Access Compliance Report

Public Rights-of-Way

(Curb Ramps)

Intersection ID: N/A	Main Street: E_4TH_ST	Cross Street: S_DAVIDSON_ST	Location: N
ADA ID: 06A814086990	Ramp Type: Perp	Initial Pass/Fail: Fail	Overall Compliance: No
Severity Score: 21.25			
Codes/Mitigation Info/Possible Solution		Field Measurements/Component Compliance

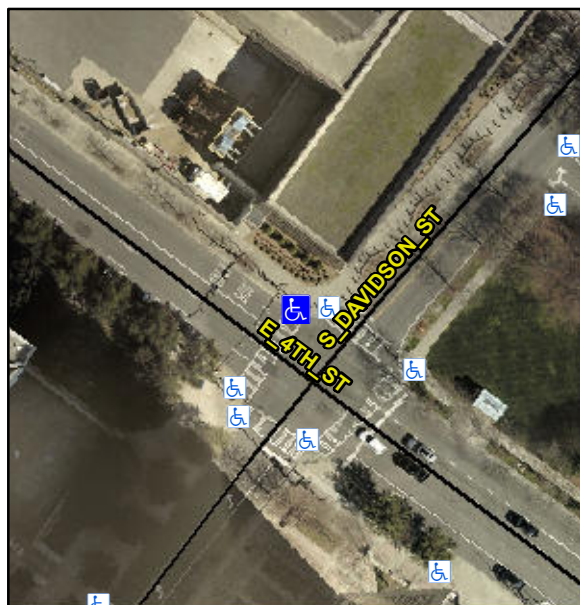
Not Found, R304.5.1, R304.5.3

Compliance	Description	Data	Compliance	Description	Data
N/A	Ramp Length (in)	60.0	Yes	Ramp Slope (%)	7.0
No	Ramp Width (in)	47.0	No	Ramp XSlope (%)	5.8
N/A	Flare Type LT	N/A	N/A	Flare Type RT	N/A
N/A	Flare Slope LT (%)	N/A	N/A	Flare Slope RT (%)	N/A
N/A	Flare Traversable LT?	No	N/A	Flare Traversable RT?	No
N/A	Landing Length (in)	N/A	N/A	DWS Provided?	N/A
N/A	Landing Width (in)	N/A	N/A	DWS Contrast?	N/A
N/A	Landing Slope (%)	N/A	N/A	DWS Length (in)	N/A
N/A	Landing X Slope (%)	N/A	N/A	DWS Full Width?	N/A
N/A	Landing Curb? (Y/N)	N/A	N/A	DWS Offset (in)	N/A
N/A	Shared Landing?	N/A			
N/A	Gutter Ponding?	N/A	N/A	Gutter Slope (%)	N/A
N/A	Gutter Lip Ht (in)	N/A	N/A	Gutter X Slope (%)	N/A
N/A	Painted X Walk1?	Yes	N/A	Painted X Walk2?	N/A
	X Walk 1 Direction	To SW		X Walk 2 Direction	N/A
N/A	X Walk 1 Width (in)	108.0	N/A	X Walk 2 Width (in)	N/A
	X Walk 1 Slope (%)	1.3		X Walk 2 Slope (%)	N/A
	X Walk 1 X Slope (%)	2.8		X Walk 2 X Slope (%)	N/A

Remove & Replace Entire Ramp.
